PLAN COMMISSION AGENDA

Consideration of Design Review Application for 400 E Main Street, Elk Property Management (Melrose on Main)

To: Village of Mount Horeb Plan Commission
From: Village Planner: Ben Rohr, AICP
Date: September 24, 2025
Re: Design Review for Exterior Changes at 400 E. Main Street

To: Village of Mount Horeb Plan Commission
From: Village Planner: Ben Rohr, AICP
Date: September 24, 2025
Re: Amendment to the Approved Specific Implementation Plan (SIP) for the Proposed 5-Story Multi-Family Building at 120 E. Front Street for Steve Brown Apartments.

Framing, Floor Plan View
1/4 in = 1 ft

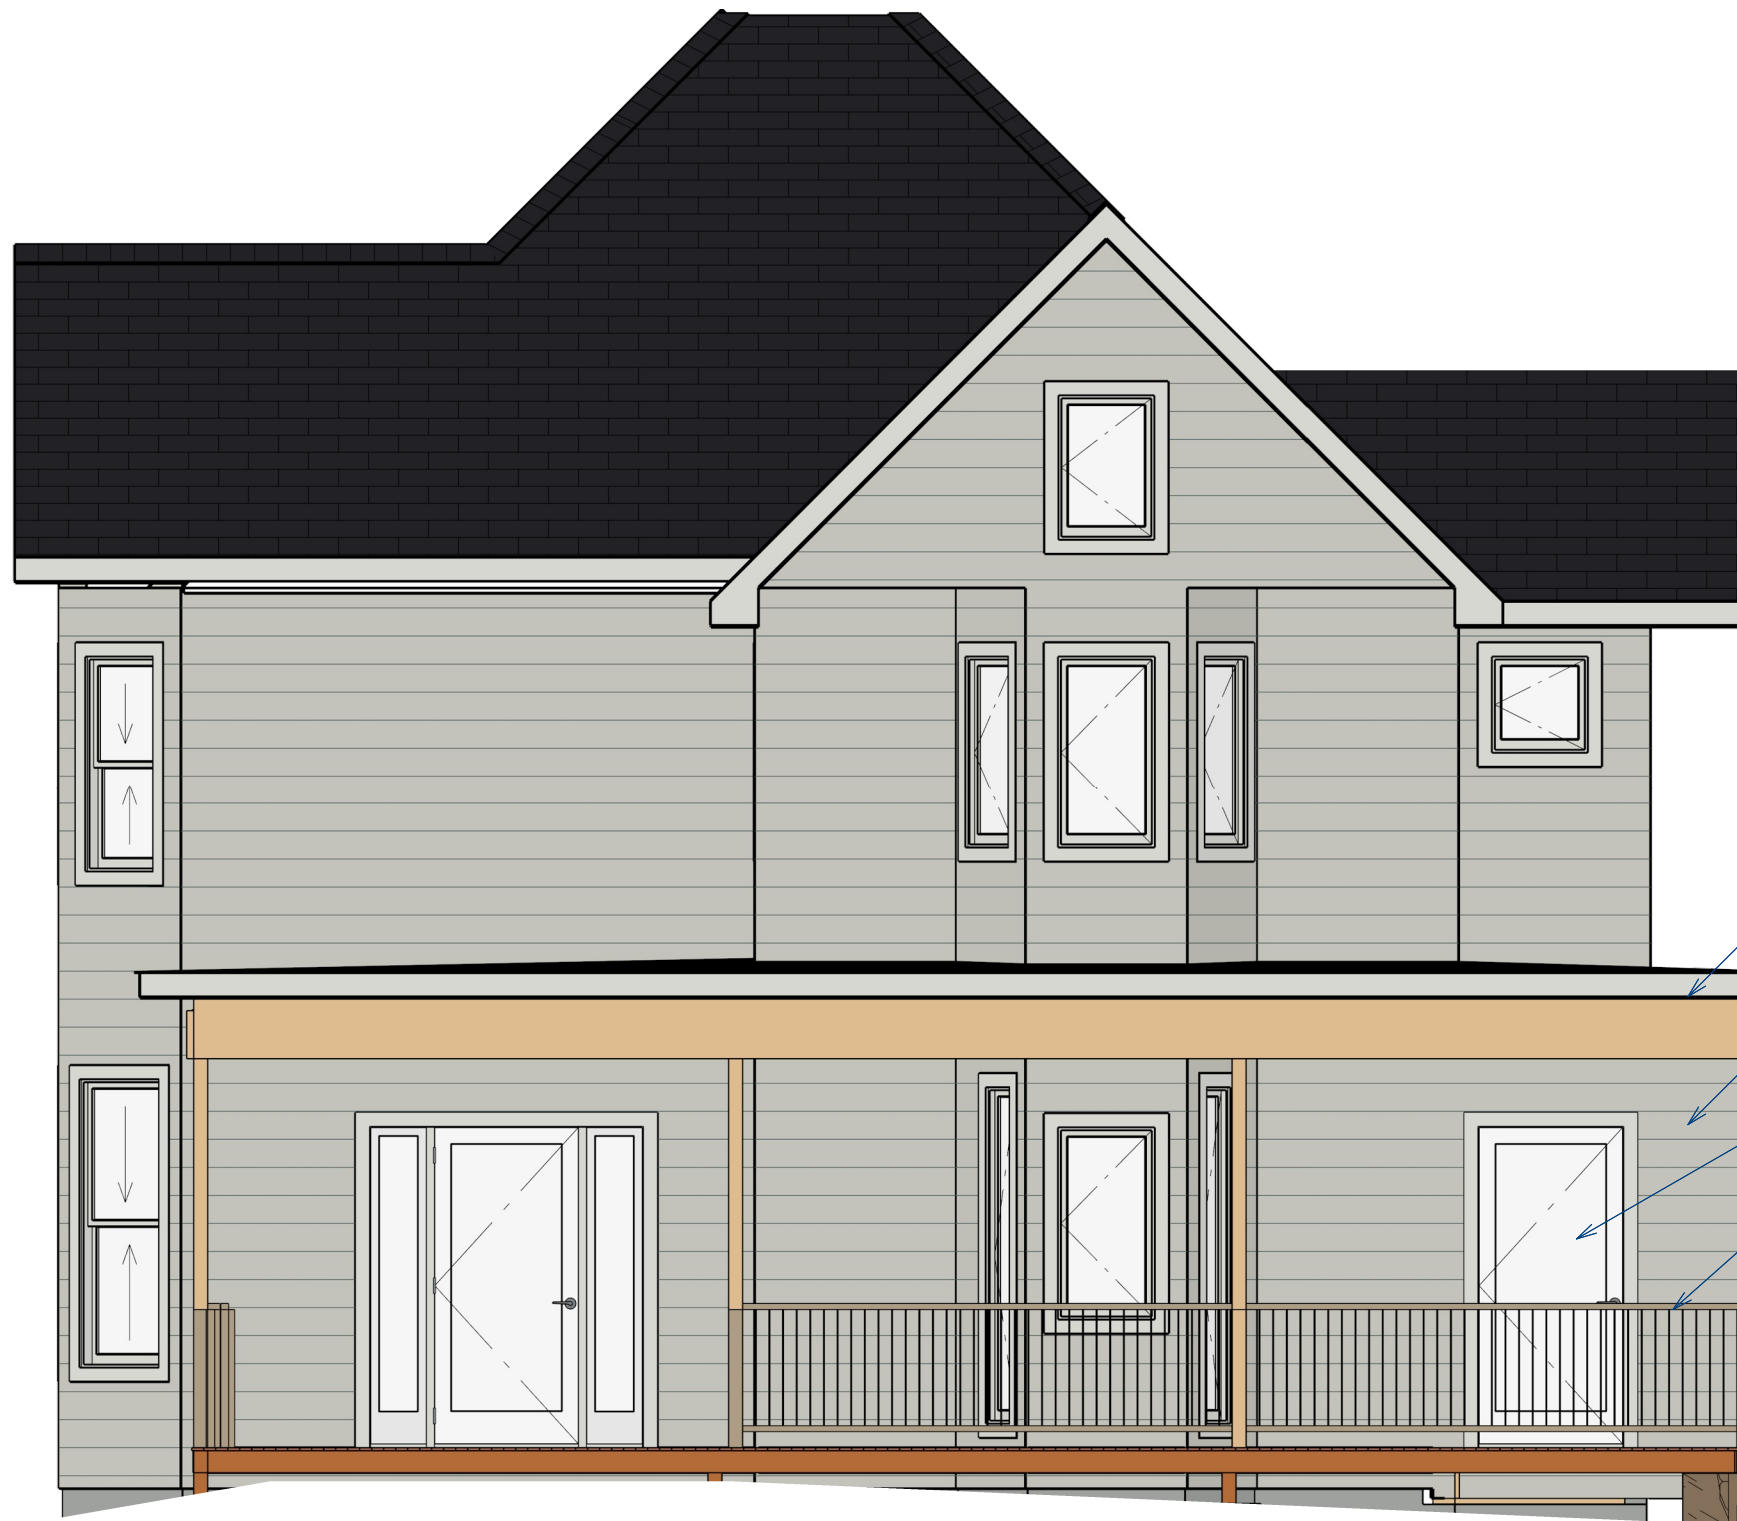
- Converting a 100 square foot portion of the existing porch at the southeast corner of the structure into a fully sheltered space to accommodate a new flower room that will be accessible from Main Street. The rest of the existing open-air porch is planned to remain.
- Adding a 528 square foot addition on the southside of the existing detached garage space to accommodate a new flower workshop space.

Both changes are proposed to match the exterior materials that are used today on the principal and accessory structures. Each will provide new interior spaces for utilization by Olson's Flowers. All other existing exterior components of the structure and site are proposed to remain unchanged.

E5 WORKSHOP WEST ELEVATION
3/16 in = 1 ft

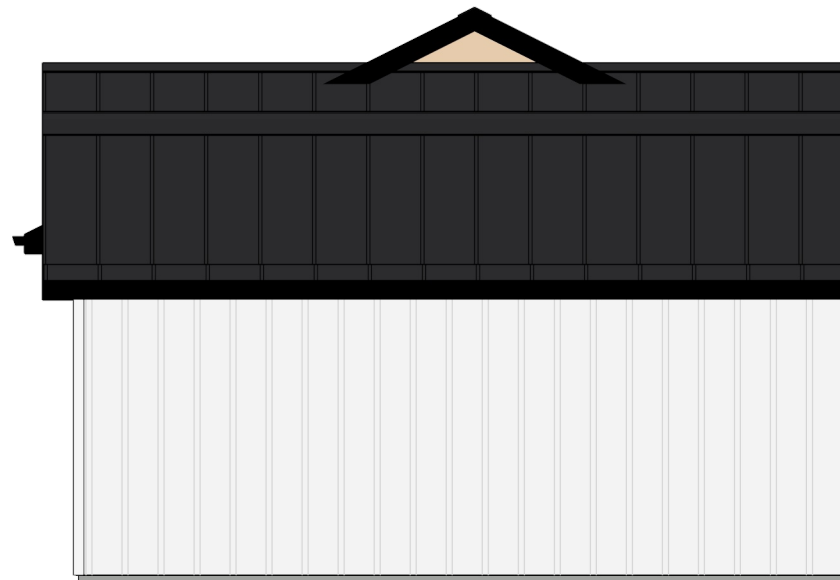
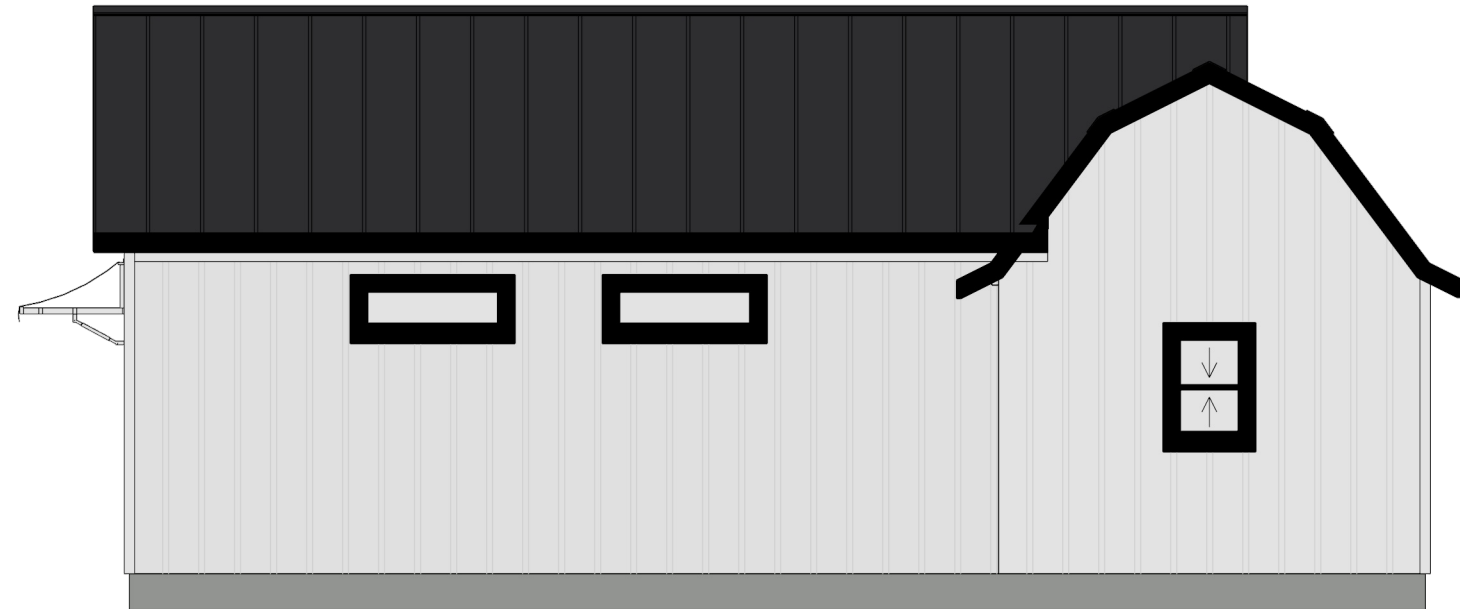
- This requirement is not met with the accessory structure because the existing structure has a metal roof, and the proposed addition matches that design. I recommend the Plan Commission waive this requirement.

- a. Awnings, where approved by the Plan Commission, shall complement the character of the building.
 - This requirement is met. The proposed awnings on the accessory structure complement the design of the structure.

- a. Outbuildings shall employ the same high-quality exterior building materials as used on the principal building.
 - This requirement is met. The accessory structure addition matches the design of the existing structure.
- b. Walls and fences shall employ high-quality materials such as metal pickets, stone, decorative block or brick which complement the principal building, as determined by the Plan Commission.
 - This requirement is met. No fencing is proposed.

1. Site Plan and Design Review packet, including waivers for:
 - a. 8.b.: Allow the façade not to include a 40” decorative horizontal base as depicted because the additions match the existing building design that does not include this element.

Approved June 2025

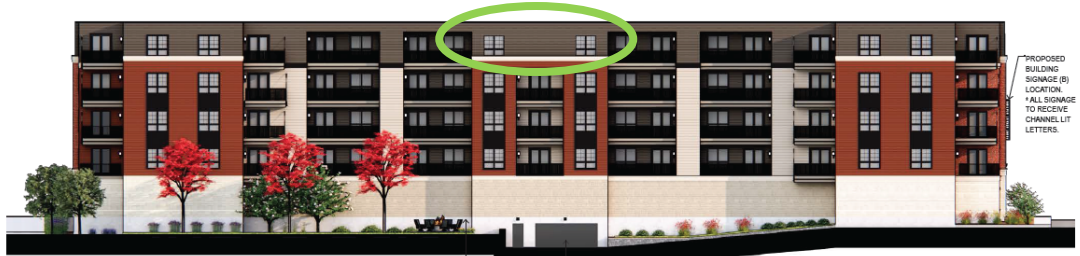
Today, Steve Brown Apartments is proposing a modification to the rear elevation of the structure. This will not change the total dwelling unit or on-site parking count within the structure. Additionally, it will not change any other façade or exterior element of the project outside of the following:

I recommend the Plan Commission recommend the SIP Amendment for 120 E. Front Street for approval by the Village Board, subject to the waivers and requirements addressed at the end of this report, as discussed and approved by the Plan Commission.
